GEOTECHNICAL MEMORANDUM

Project: Kurnabinna Gully Bridge – Geotechnical Reassessment and Redesign

In response to the provision of revised loads, CMW Geosciences (East Coast) provide the following geotechnical reassessment and redesign for the Kurnabinna Bridge, as part of the Walkway Upgrade Project.

Design Drawings Revised

Figure 1: Section view of revised reinforcement – Kurnabinna South.

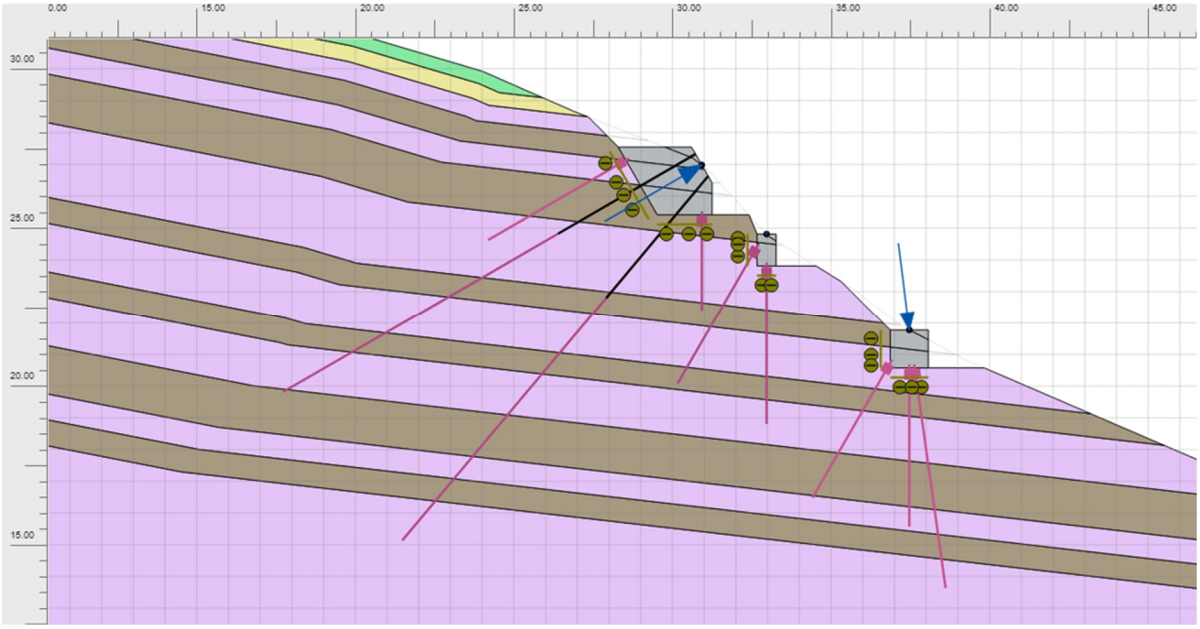
Figure 1 and Figure 2 provide section views of the revised reinforcement for each bridge abutment. **Appendix A** has a revision of the existing design drawings with the revised details annotated therein.

DRAWING NUMBER: J0439-STR-SKT-0110

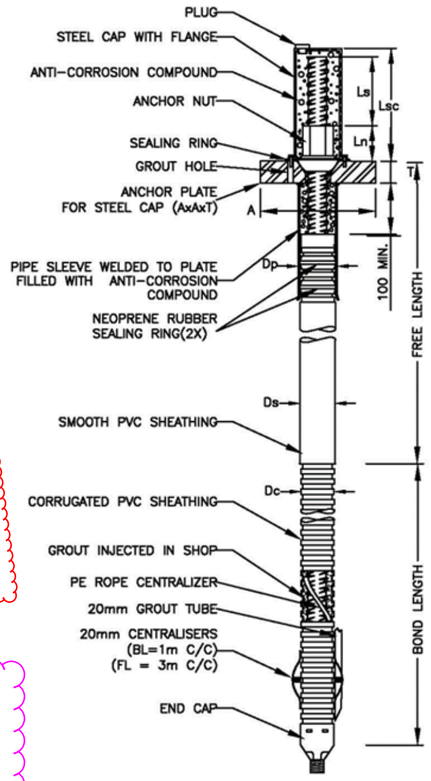
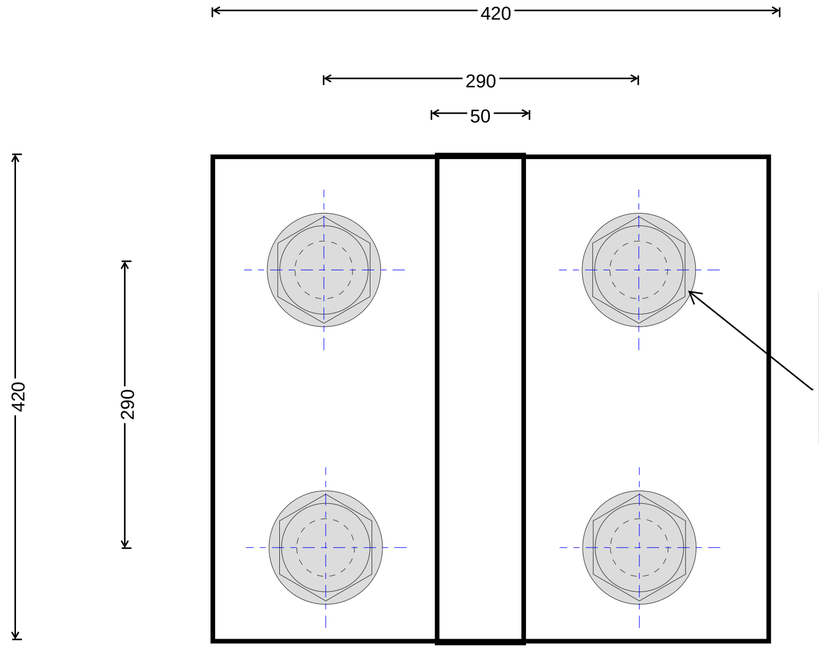
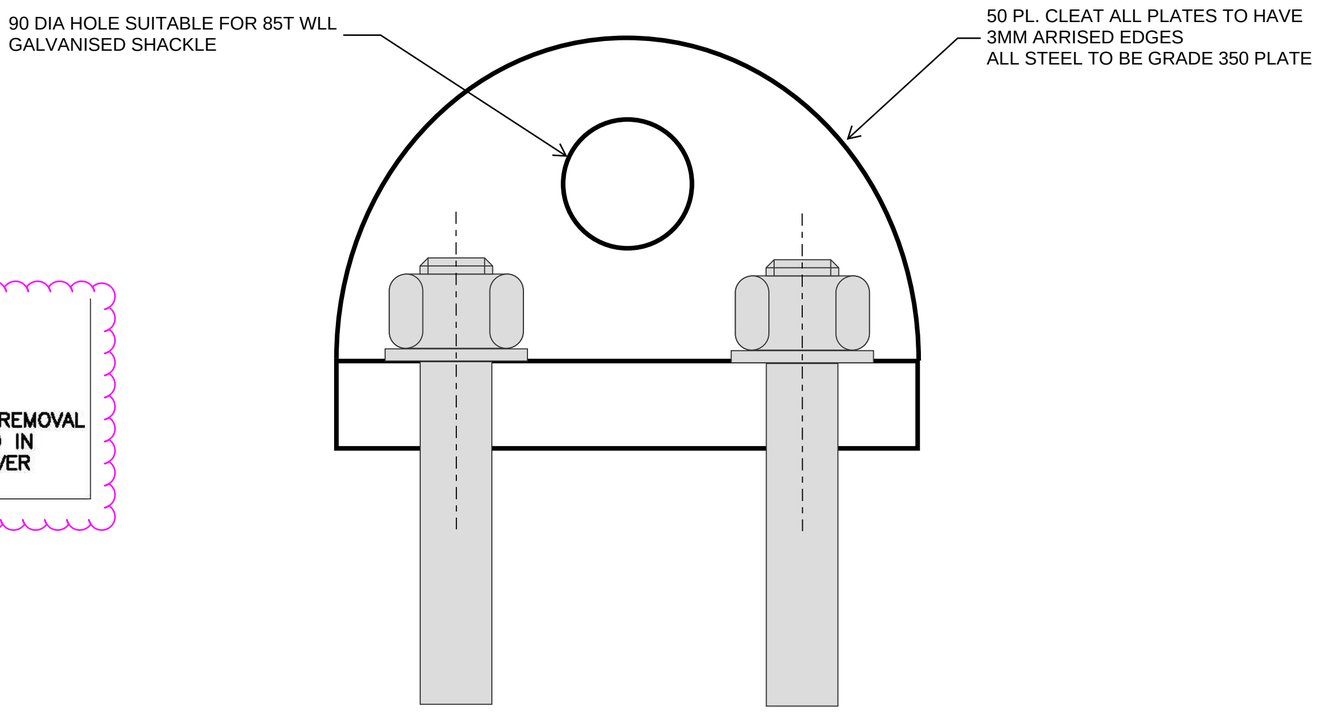
This area is assumed to be removed during construction

Green line is the new block perimter. This is to embedd the 40mm bar and ensure cover.

above text to adjusted to reference the 6 starnd multistrand configuration

new 40mm threaded DCP bar.

new 40mm threaded DCP bar.

Edits 15/08/22 J Slade

CMW have assessed the live and dead design loads and a temporary loading of 0.05g horizontal loading.

Design is predicated on the pull testing of the cable and thread bar anchors at regular intervals to confirm design capacity is meet.

All temporary works excavations and Temporary Anchors are not to interact with these permanent anchor elements

Drawing is to also include the DWG-PermStrand01 - Permanent Strand Anchor Details as attached in this report.

Text to be removed as it also written below.

DRAWING NUMBER: J0439-STR-SKT-0112

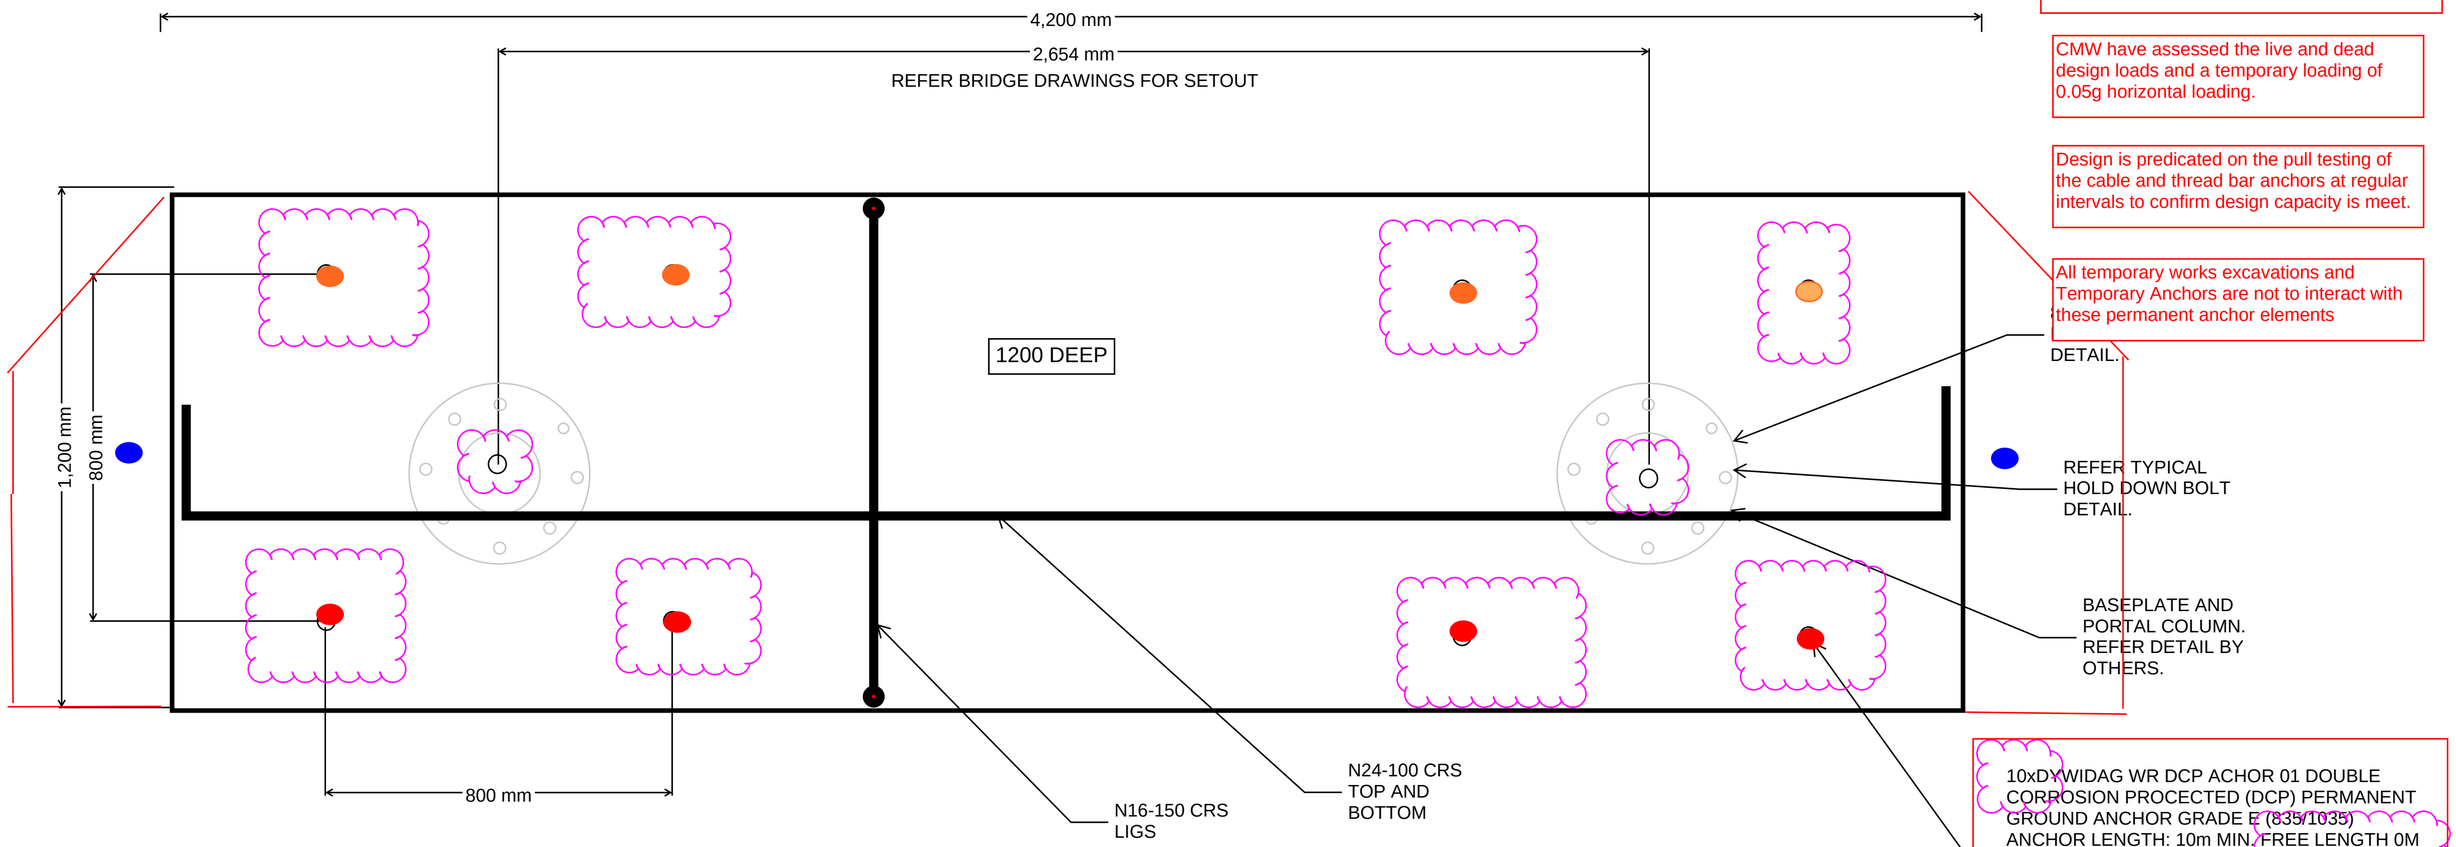
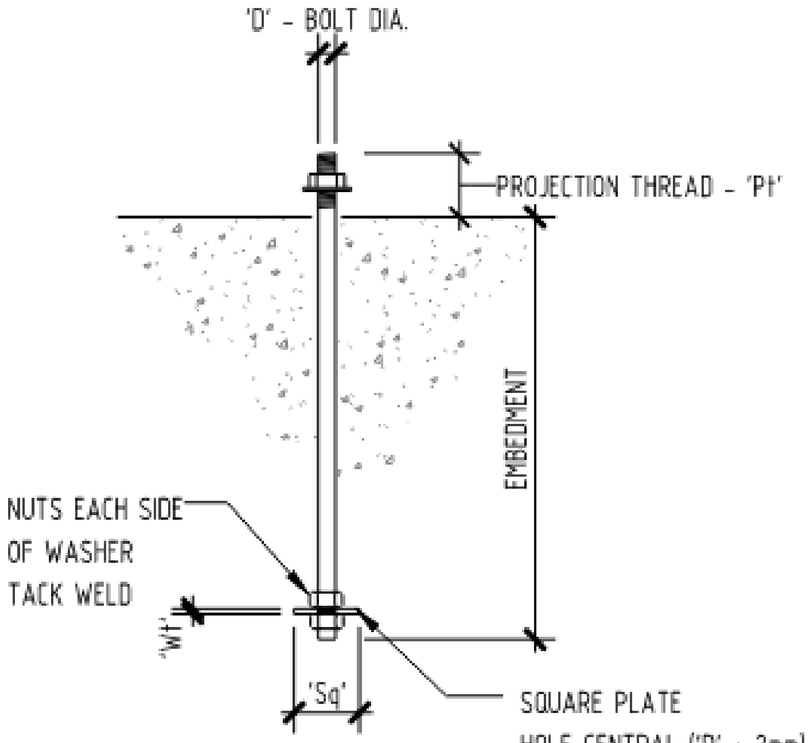
Edits 05/08/22 J Slade

CMW have assessed the live and dead design loads and a temporary loading of 0.05g horizontal loading.

Design is predicated on the pull testing of the cable and thread bar anchors at regular intervals to confirm design capacity is meet.

All temporary works excavations and Temporary Anchors are not to interact with these permanent anchor elements

text to revised to 40mm threaded DCP bar.

DRAWING NUMBER: J0439-STR-SKT-0113

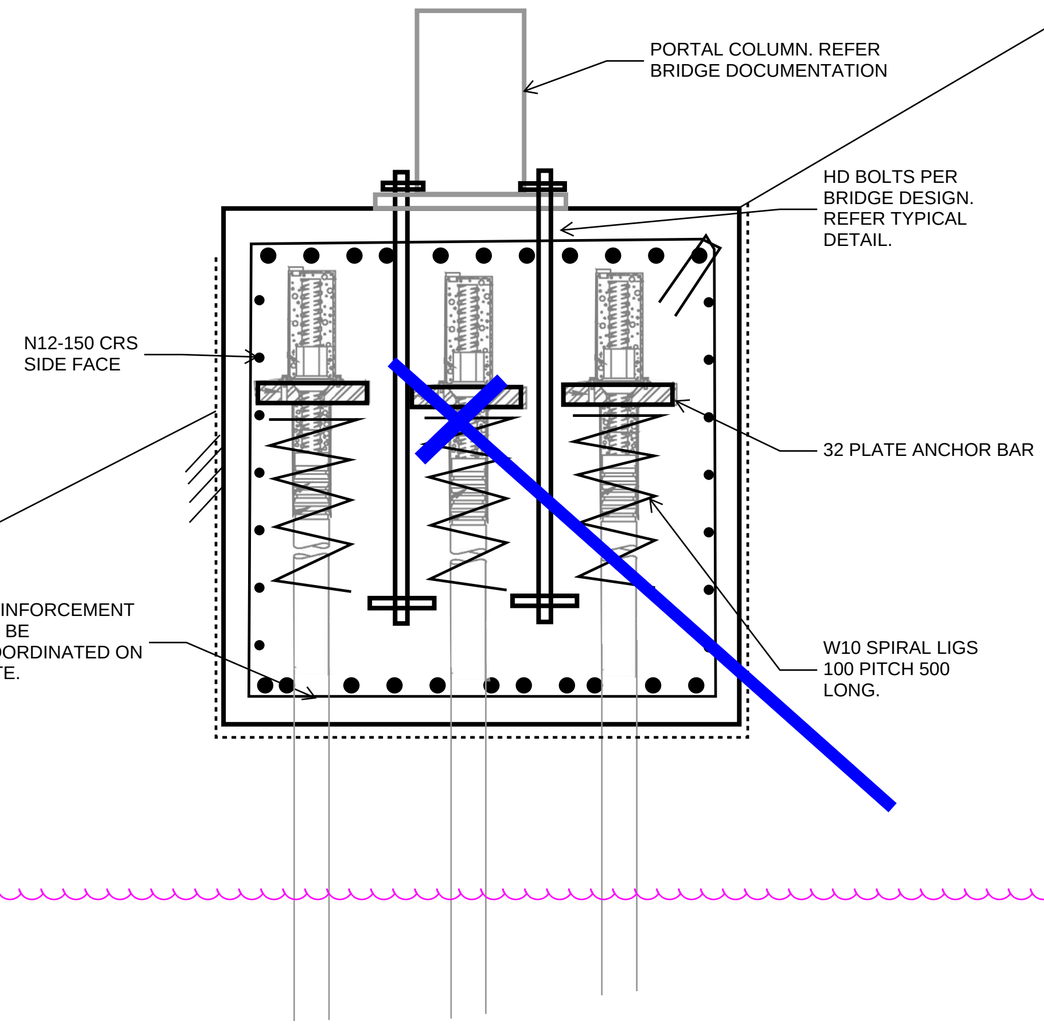
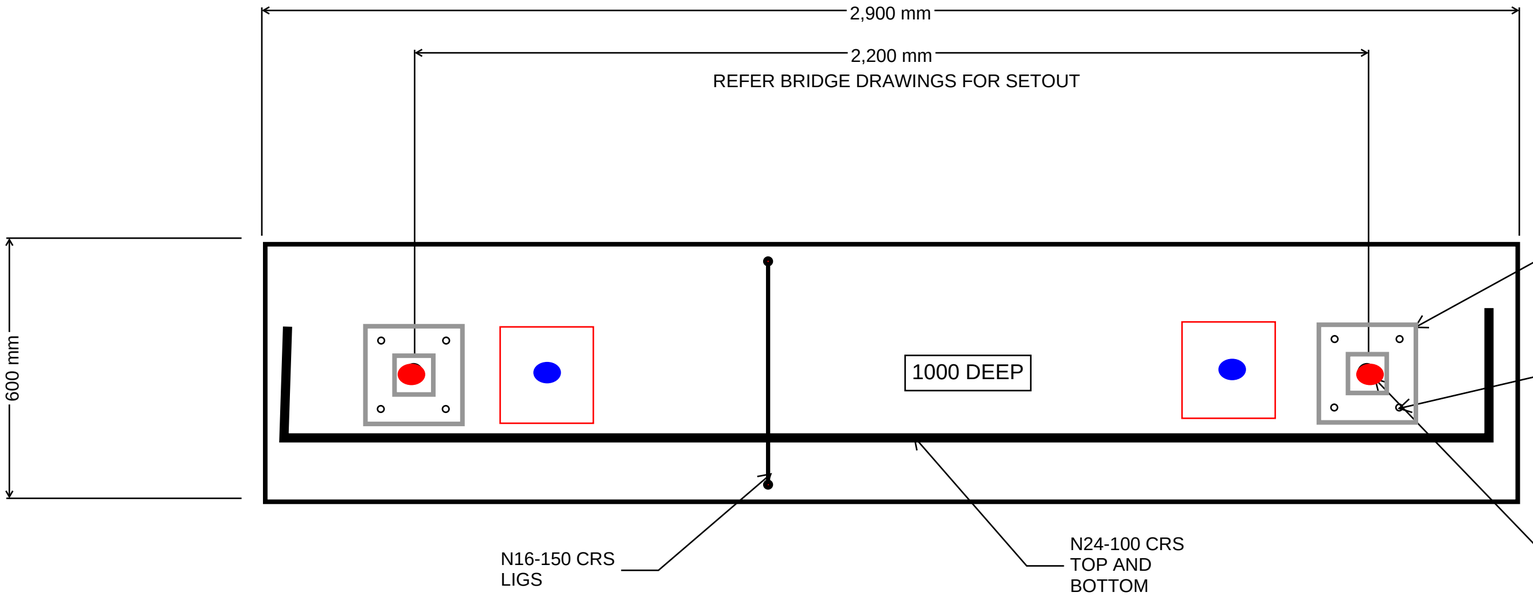
Edits 05/08/22 J Slade

In above section - central 40mm DCP threaded bar is inclined / raked into slope (see blue line)

DRAWING NUMBER: J0439-STR-SKT-0114

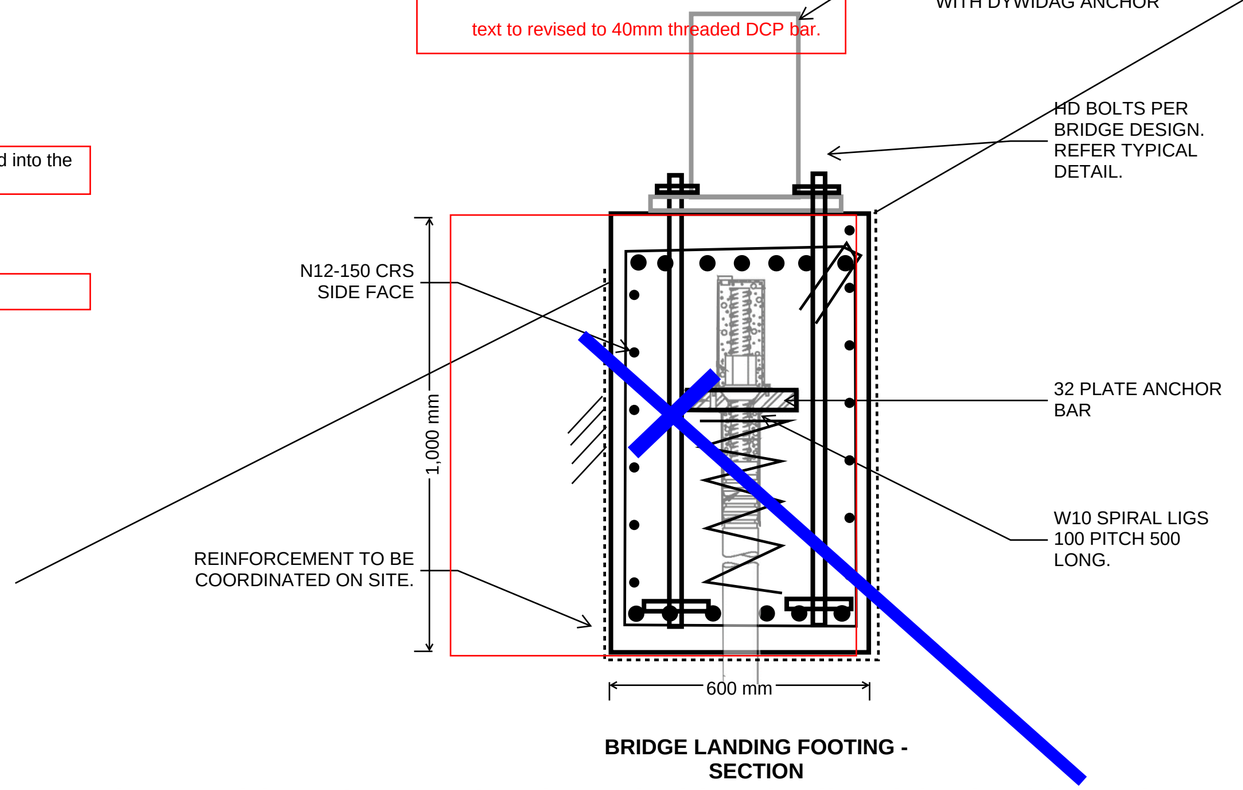
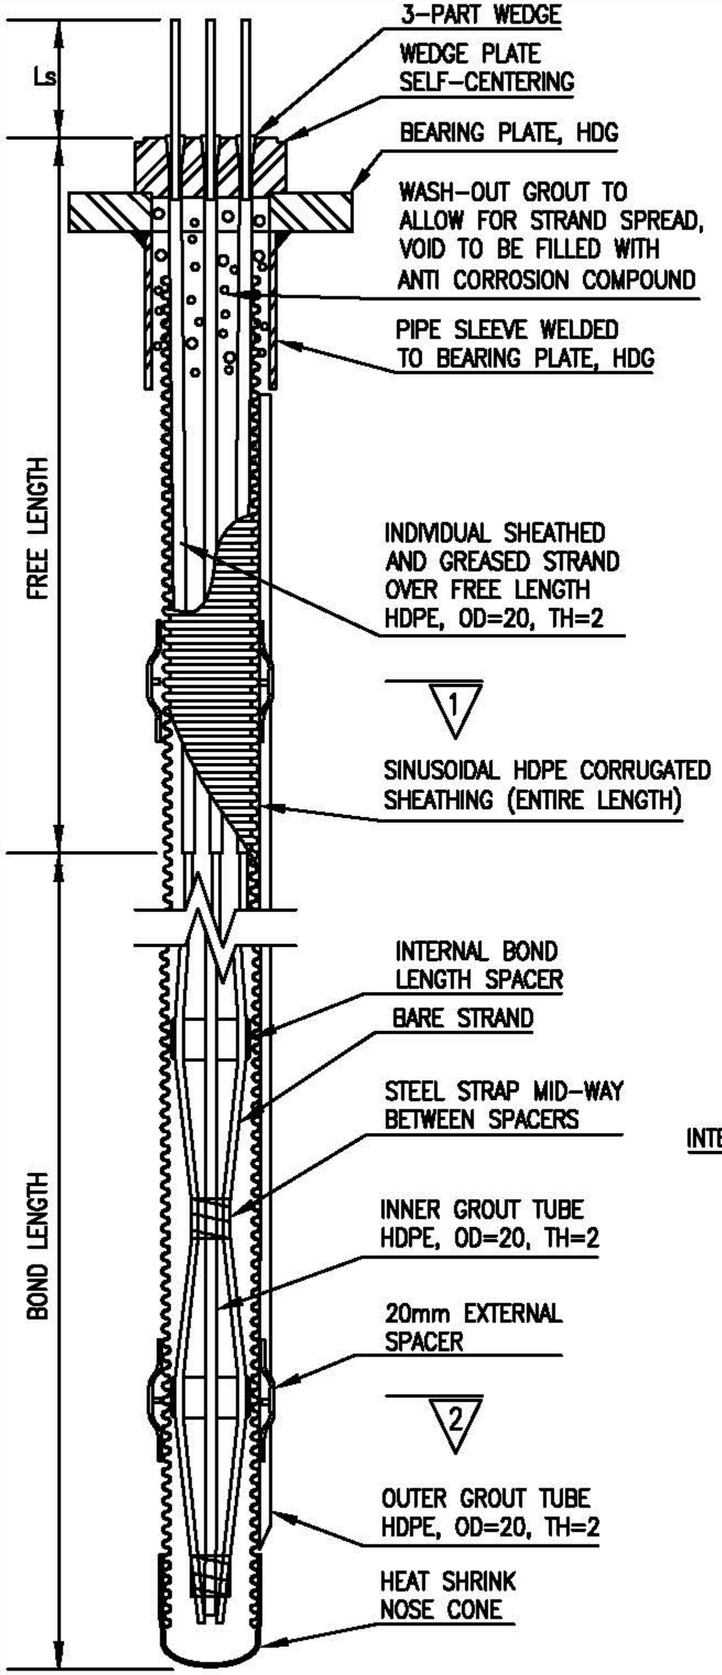
Edits 05/08/22 J Slade

CMW have assessed the live and dead design loads and a temporary loading of 0.05g horizontal loading.

Design is predicated on the pull testing of the cable and thread bar anchors at regular intervals to confirm design capacity is meet.

All temporary works excavations and Temporary Anchors are not to interact with these permanent anchor elements

In above section - add a 40mm DCP threaded bar inclined / raked into slope (see above blue line). This is likely to change the dimensions of the block
